**From:** Daniel Cheng [dwacheng@lbl.gov](mailto:dwacheng@lbl.gov)   
**Subject:** Deviation request and/or DCR proposal  
**Date:** September 8, 2020 at 4:03 PM

We've been having an issue with our axial rods, and I wanted to give you the heads up on a proposal we'd like to make for either a Deviation for just MQXFA06, or a DCR for the rest of the magnets. A little bit of back story:

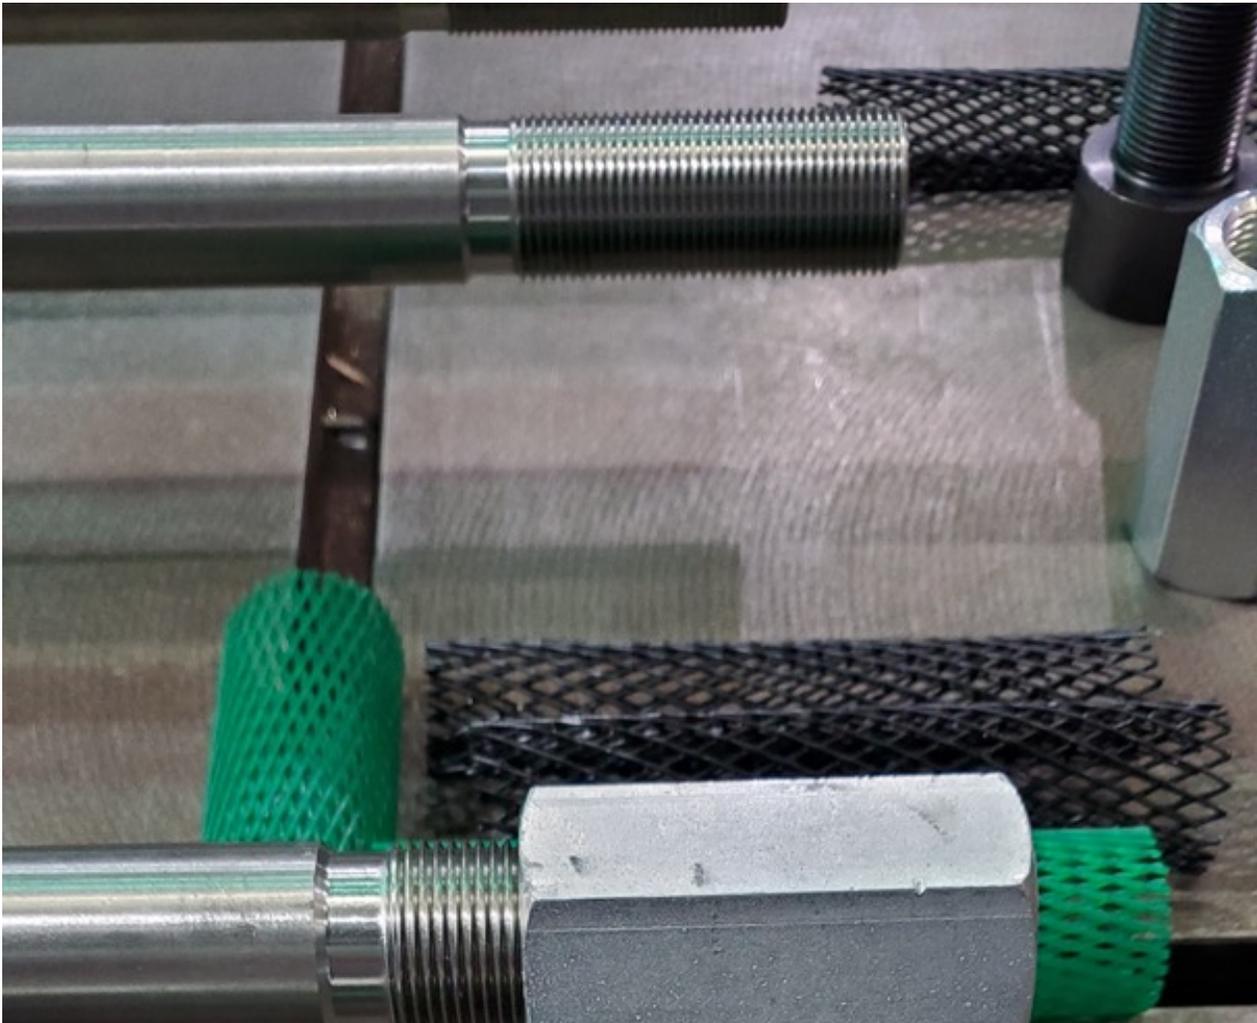
The vendor who machined the rods has apparently been having an issue with the thread pitch, which is ever-so-slightly off, to the effect that ~2" or less of rod engagement into the Nitronic end plate is okay, but any more thread engagement begins to bind up. We had noticed this with earlier magnets, but we finally tracked it down to it being the pitch issue; we even had the vendor come on site to observe the issues we were having with the batch of rods for A05-A08 orders, after which we sent these rods back for rework. After getting them back we are finding this issue still persists.

The enclosed picture shows a 3" long threaded coupler nut at the point where it begins to bind. The attached PDF redline is the fix that we are proposing.

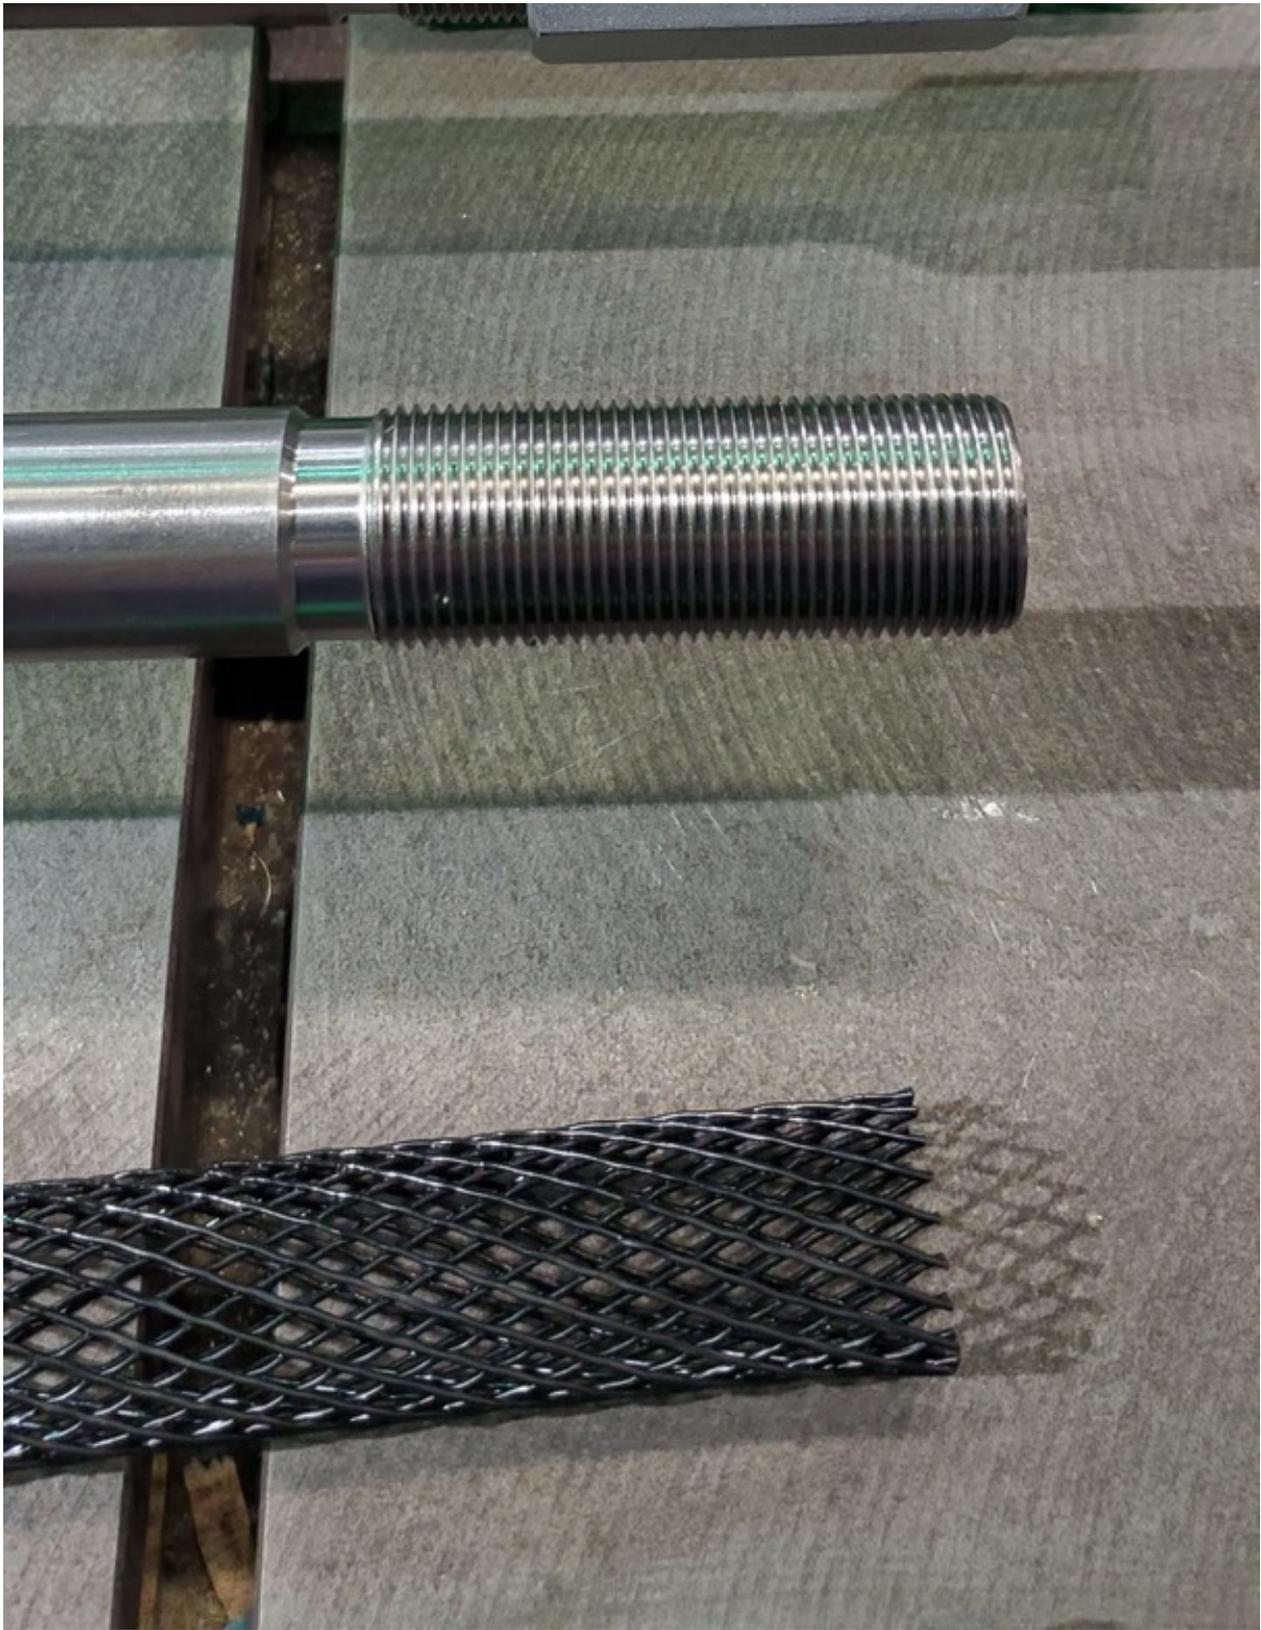
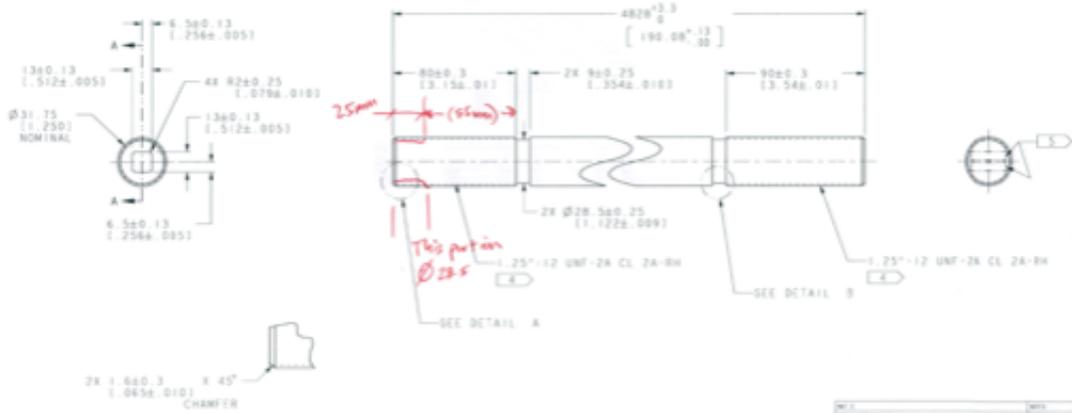
This redline proposal (for either a DR or DCR) is to remove the last ~1" of the thread so that we can fully screw the axial rods into the Nitronic endplate without binding, but still maintain the same loading on the threaded contact area as before. It's only the first part of the threads that take up the full load, so removing the "backend" of the threads doesn't change the loading condition on the threads or plate.
